7730 15TH AVE NW

Design Review Recommendation

July 18, 2016

SDCI Project # 3021006

^ 3D diagram (from SE corner) of departure request

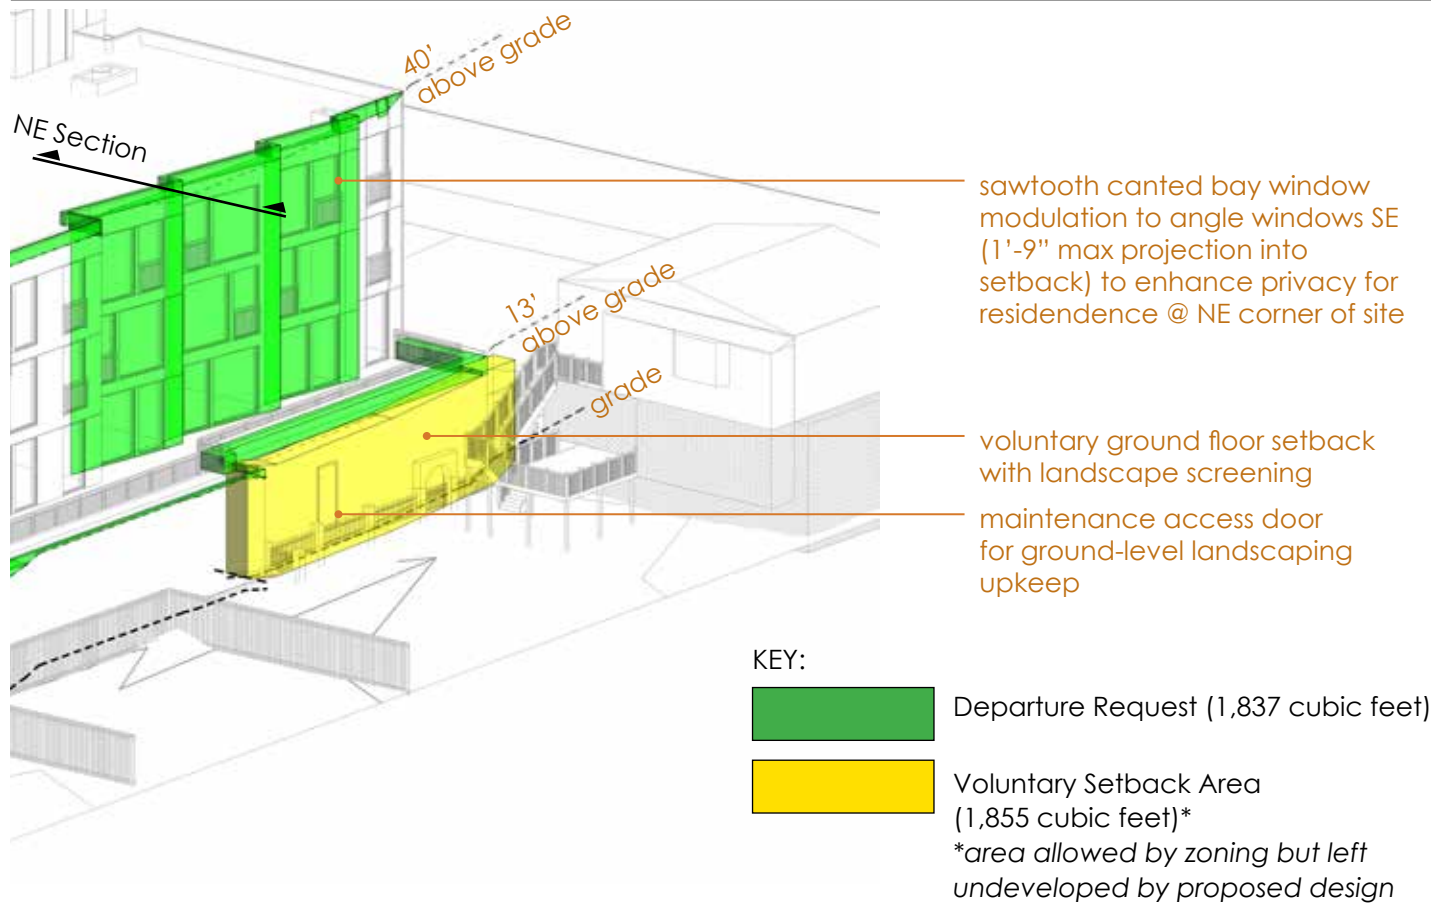
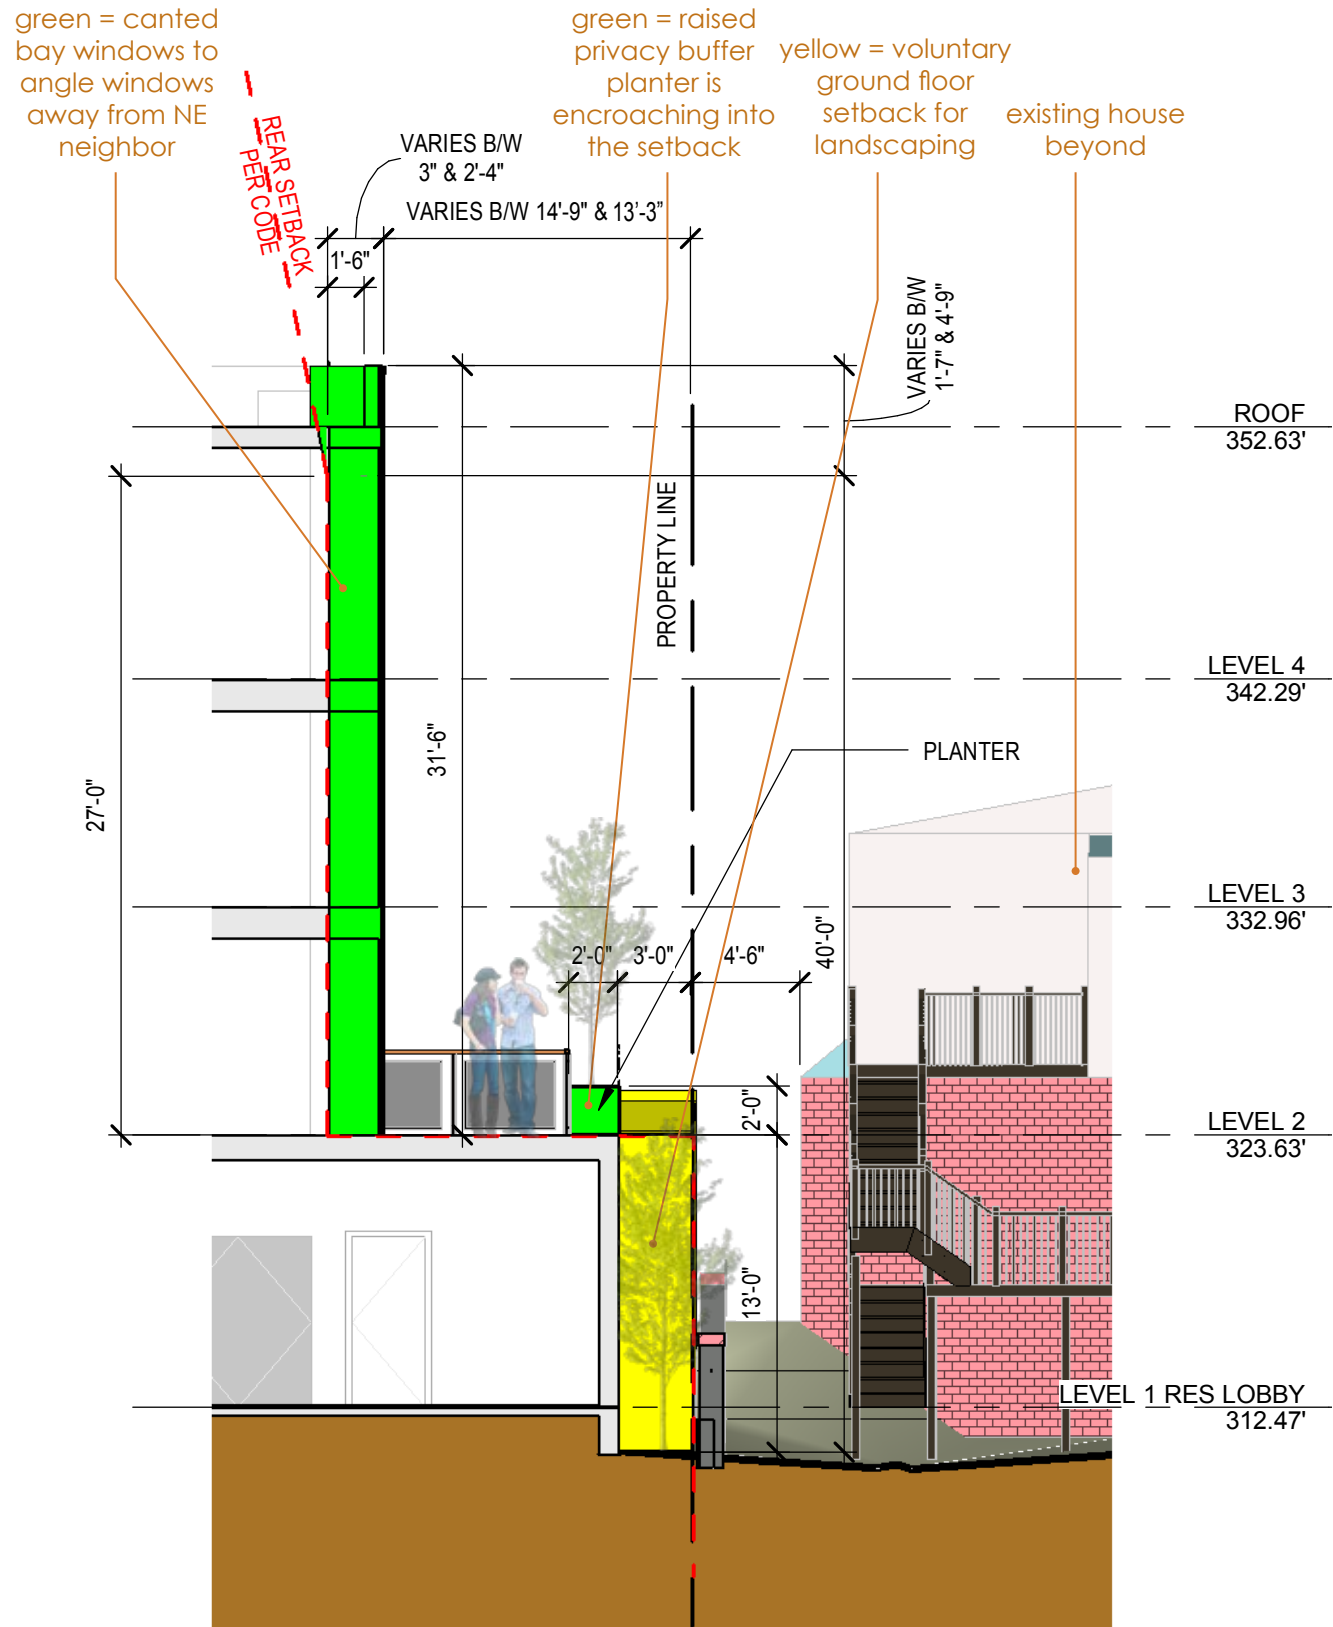
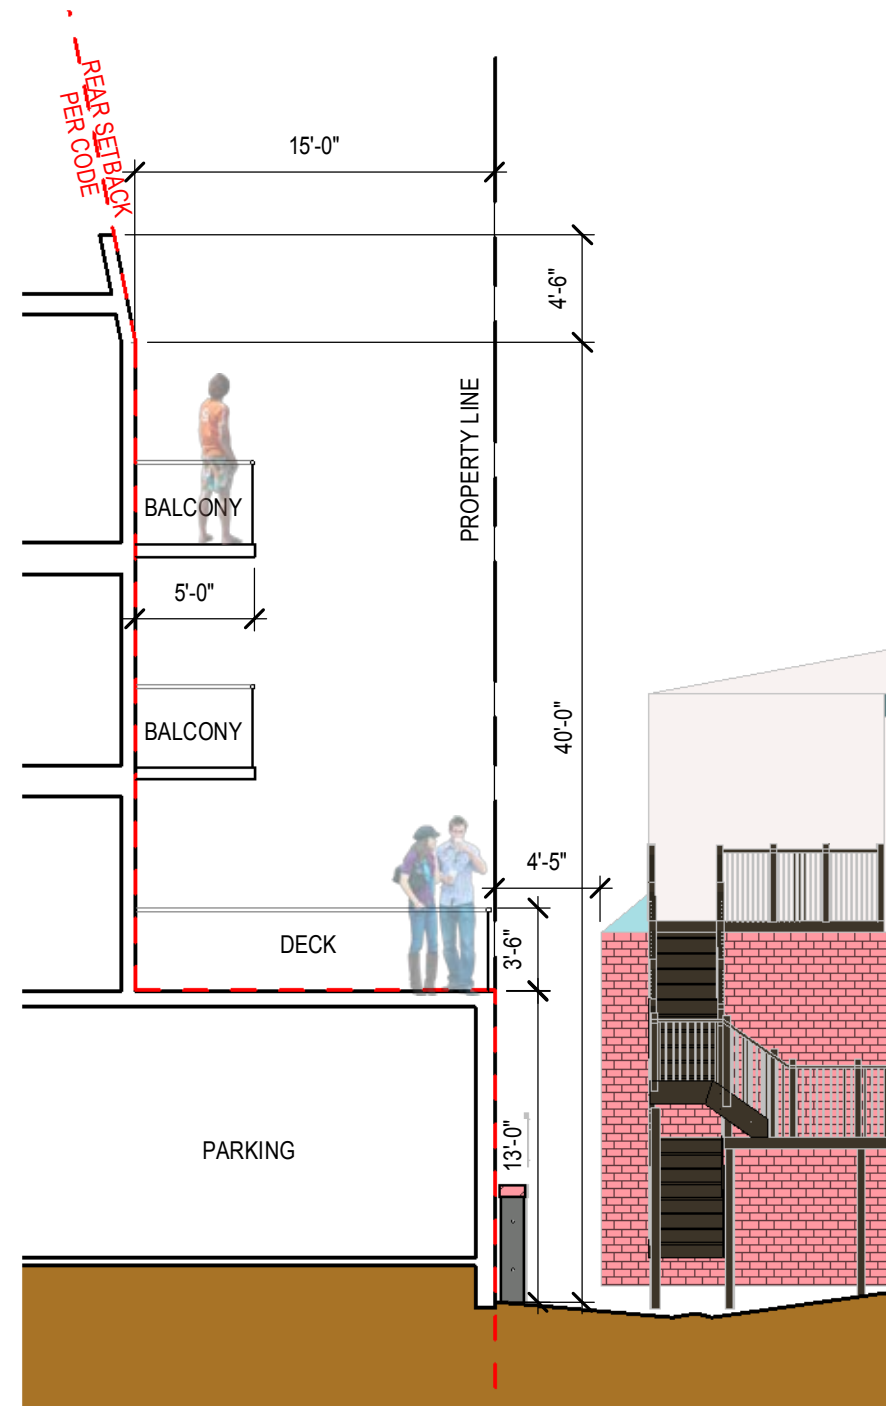
DEPARTURE	CODE REQUIREMENT	PROPOSED DESIGN	JUSTIFICATION
Side setback at east lot line bordering a residential zone - LEVELS 2-4	SMC 23.47A.014 B 3 a The code requires a 15' setback above 13' height abutting a residential zone. A 0' setback is required up to 13' height	A series of projecting sawtooth modulation bays are proposed, projecting 1'-9" max horizontally (reducing the 15' setback to 13'-3") within the east setback near the NE corner to protect the privacy of the NE neighbor. A landscaped raised planter buffer 2'-6" tall and 2' deep is proposed at the 2nd floor deck within the setback for privacy screening. A voluntary 3'-2" ground floor setback is also provided to allow for at-grade landscaping	To better provide an appropriately-scaled transition to the neighboring SF-5000 property to the NE, the ground floor has been set back 3'-2" from the property line to allow for landscape screening along the garage wall and reduced bulk directly adjacent to the existing house, deck, and yard (GUIDELINE DC2.A.2: REDUCING PERCEIVED MASS AND CS2.D.3: ZONE TRANSITIONS), even though no setback at the ground level is required by code. Above the ground floor, sawtooth modulation bays with canted/angled windows are proposed along the portion of the east facade adjacent to privacy-sensitive areas to help protect the privacy of the NE neighboring residence. The angle of the windows will direct views from apartment windows further to the south, where adjacent SF-5000 properties are protected by deep yards and dense existing vegetation. The sawtooth modulation also provides an opportunity for varied siding treatment, and helps to break down the apparent scale of the upper floors to better fit the smaller-scale development to the east.

Side setback at east lot line bordering a residential zone - ROOF PARAPET	SMC 23.47A.014 B 3 b The code requires a 15' setback above 13' height + a 2:10 sloped setback at portions above 40' height	Due to existing topography fluctuations and provided modulation, several small zones up to 4'-9" tall and 2'-4" deep along the top of the roof parapet are in the setback area, resulting in a 13'-3" setback instead of an up to 16' required setback along the top of the parapet line	The east facade has been modulated to break down the scale of the east facade and to direct window views away from privacy-sensitive areas to better provide a transition to adjacent single family zoning (GUIDELINE CS2.D.3: ZONE TRANSITIONS). In order to ensure an overall well-proportioned and composed facade that has an appropriate amount of visual depth and interest--given the vertical bay modulation proposed--the east elevation maintains a vertical continuum along the height of the facade instead of sloping back along the setback line (GUIDELINES DC2.B.1: FACADE COMPOSITION and DC2.C.1: VISUAL DEPTH AND INTEREST). A code-compliant design would be a flat, unmodulated east facade with an inward slope at the top along the sloped setback line above 40' in height.

Side setback at east lot line bordering a residential zone - DOOR LOCATION	SMC 23.47A.014 B 5 No entrance or opening is permitted within 5' of a residentially-zoned lot	In order to maintain a ground-level landscaping buffer, a non-transparent maintenance access door is proposed 3'-2" from a residentially-zoned lot	An increased ground floor setback is proposed to better provide a bulk transition to adjacent single family zoning (GUIDELINE CS2.D.3: ZONE TRANSITIONS). Within this setback area, ground-level landscaping is proposed to visually soften the textured concrete garage wall. The proposed access door (intended for maintenance access only and containing no glazing or transparency) is needed for proper maintenance of the landscaped area.

^ Perspective view of south facade from 15th Ave NW (preferred design)

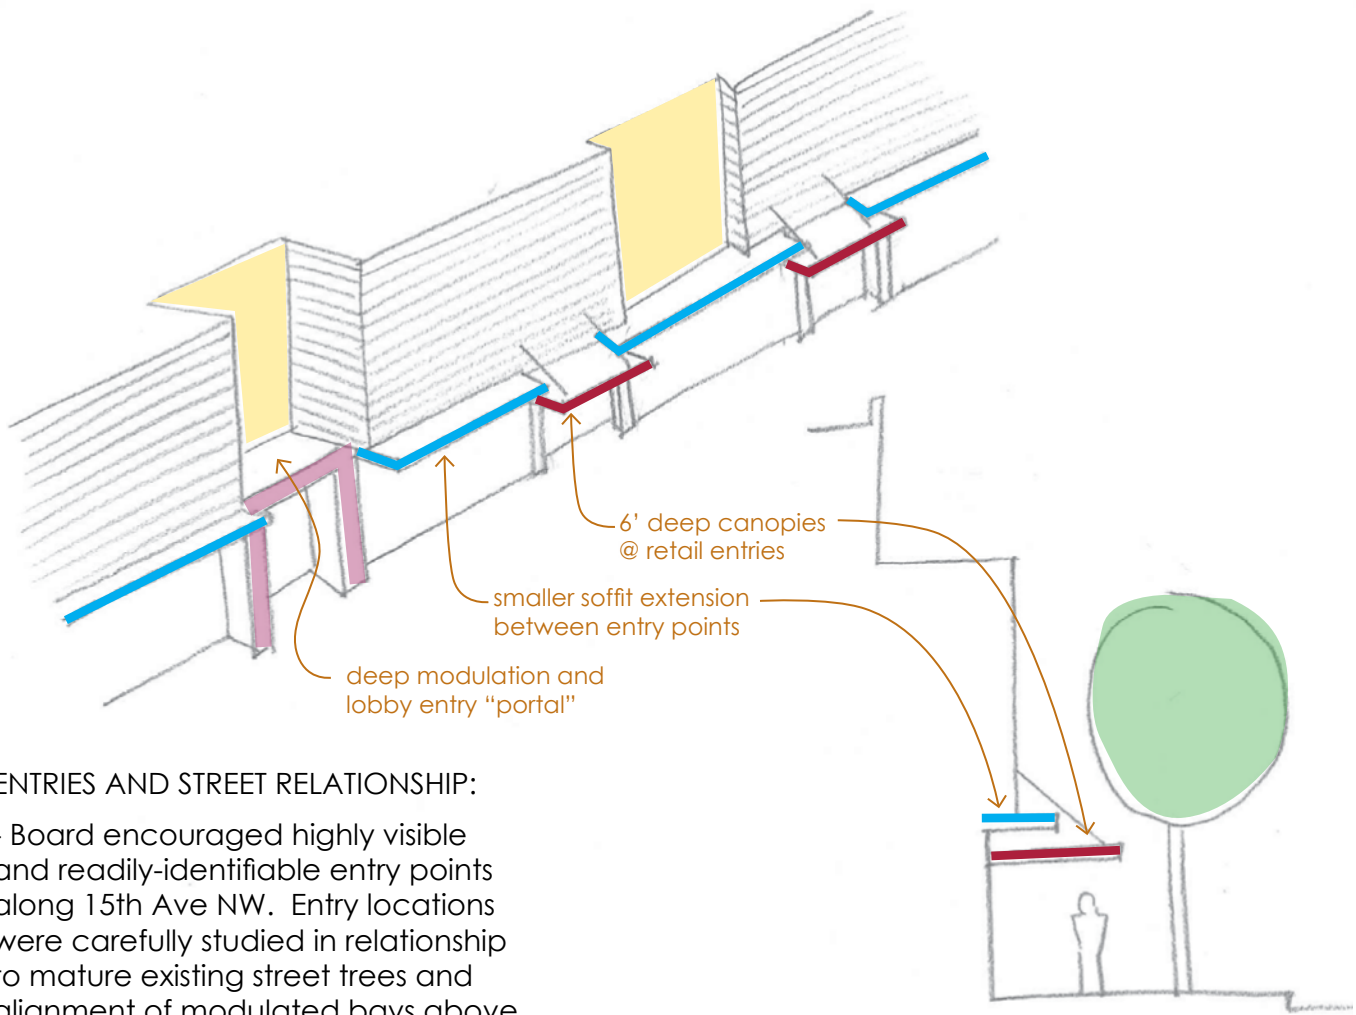
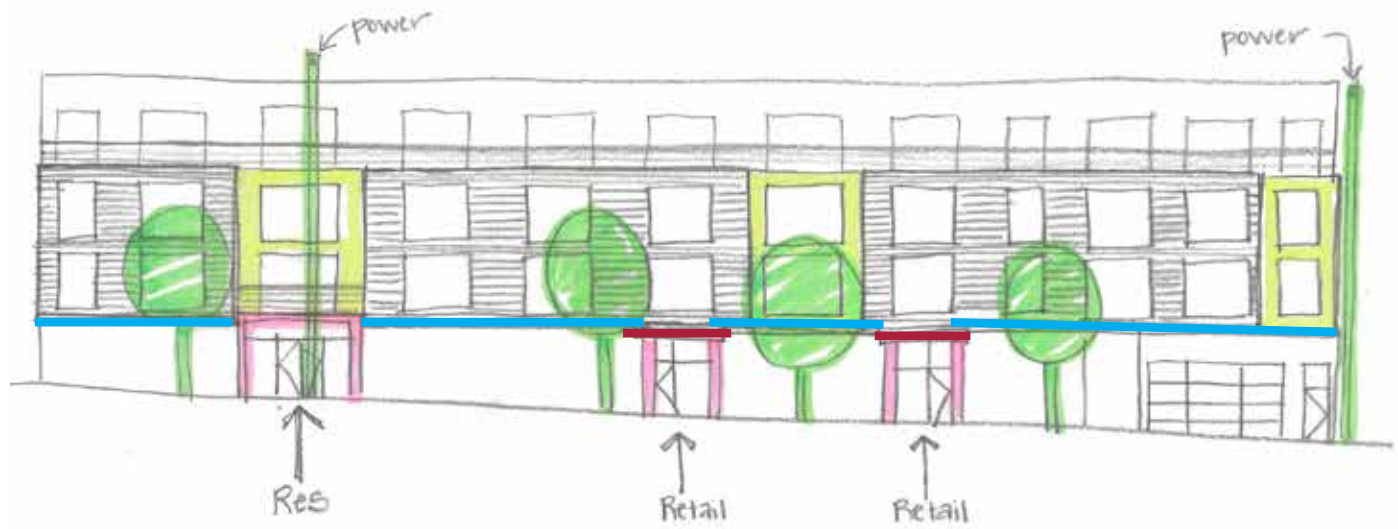
- Due to the mid-block condition of the project, north and south walls will have limited fenestration in preparation for future adjacent development. The Board requested further development of the blank wall treatment.

- Design response includes an increased setback at the center portion of each facade to allow limited windows and modulation relief, and an attractive artistic cladding pattern.

^ study of canopy/entry alignment with existing trees

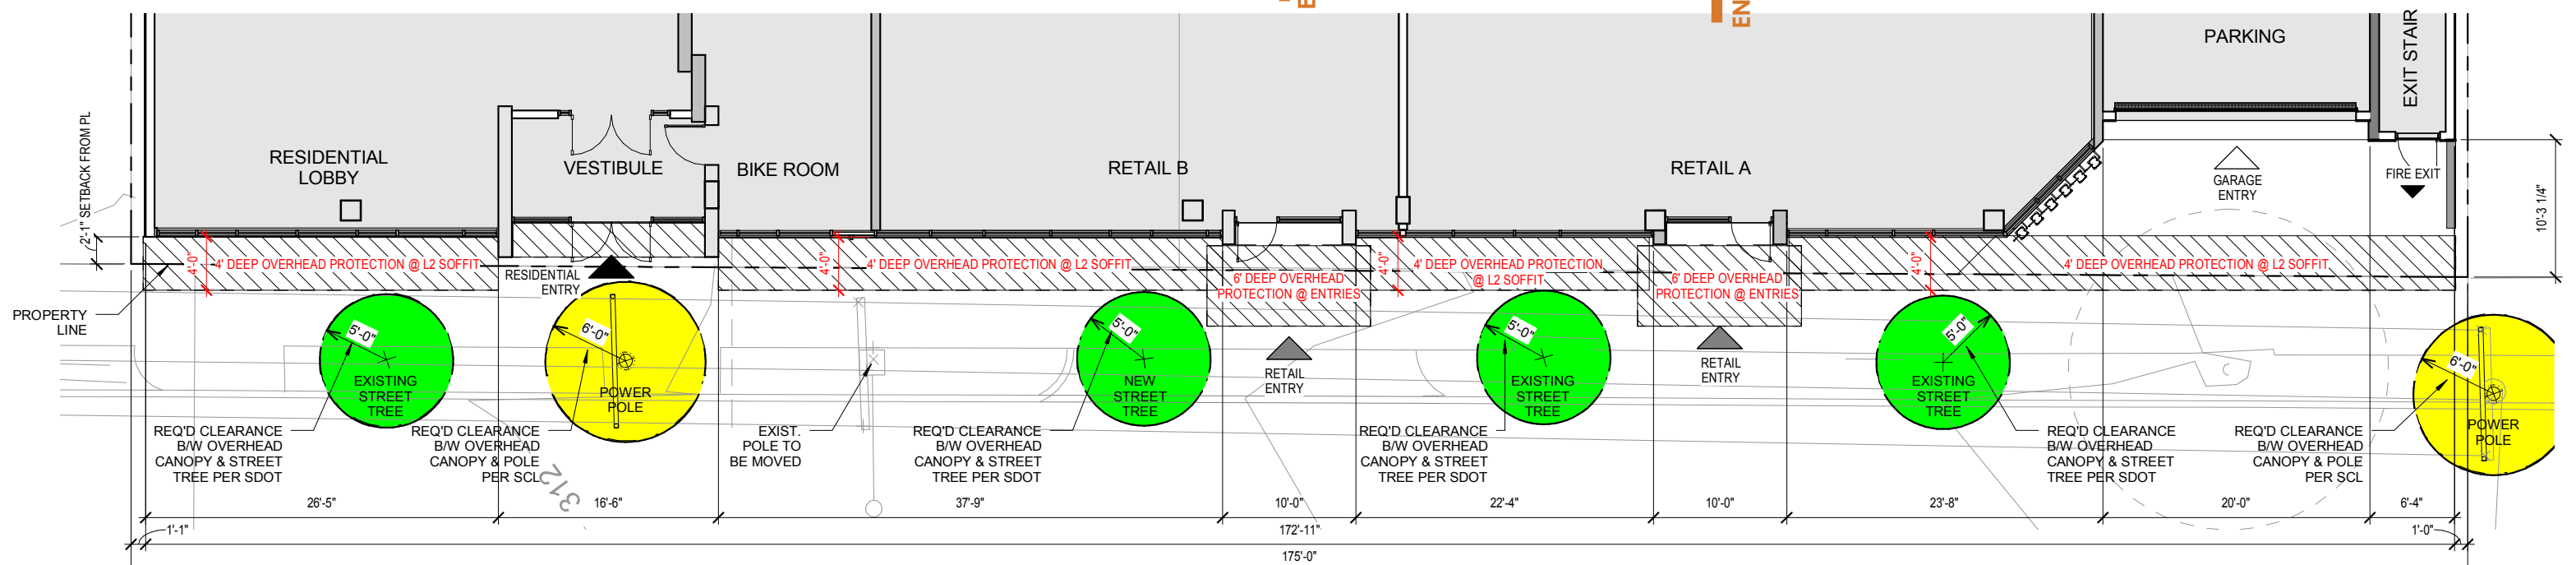
- Board encouraged highly visible and readily-identifiable entry points along 15th Ave NW. Entry locations were carefully studied in relationship to mature existing street trees and alignment of modulated bays above
- Size of mature street trees and presence of power poles mandates a modulated canopy. Larger canopies at retail entry points and deep modulated recess above main entry enhances pedestrian wayfinding

DEPARTURE	CODE REQUIREMENT	PROPOSED DESIGN	JUSTIFICATION
Overhead weather protection	SMC 23.47A.008.C.4 b Along 15th Ave NW (a Principal Pedestrian Street), the code requires overhead weather protection for 60% of the street frontage for a minimum width of 6' unless there is a conflict with street trees or utility poles	Due to (3) existing and (1) proposed street trees --which require 5' trunk clearance by SDOT--and (2) power poles--which require a 6' clearance from City Light, project proposes: <ul style="list-style-type: none"> - 6' wide canopies at retail entries (14% of the facade length rather than the 60% required) - a 2.5' deep entry 'portal' to mark the residential entry lobby - 4' wide canopies/soffits along the remaining frontage 	In order to better emphasize the entries and create a simplified well-composed facade, the project proposes to align the canopy modulation with the entries and overall architecture (GUIDELINES PL2.C.2: WEATHER PROTECTION DESIGN INTEGRATION and PL3.A.1: ENTRY DESIGN OBJECTIVES and DC2.B.1: FACADE COMPOSITION). To highlight retail entry points (which are located between street trees for street visibility), a 6' wide canopy is proposed. At the entry lobby, deep modulation of the building above is proposed to mark the main entry. Between entry points, the project proposes continuous 4' wide weather protection (the maximum width allowed without encroaching in the required street tree buffer). In a code-compliant design, the canopy would modulate in and out around the street trees with no relationship to building entries or the modulation of the facade.
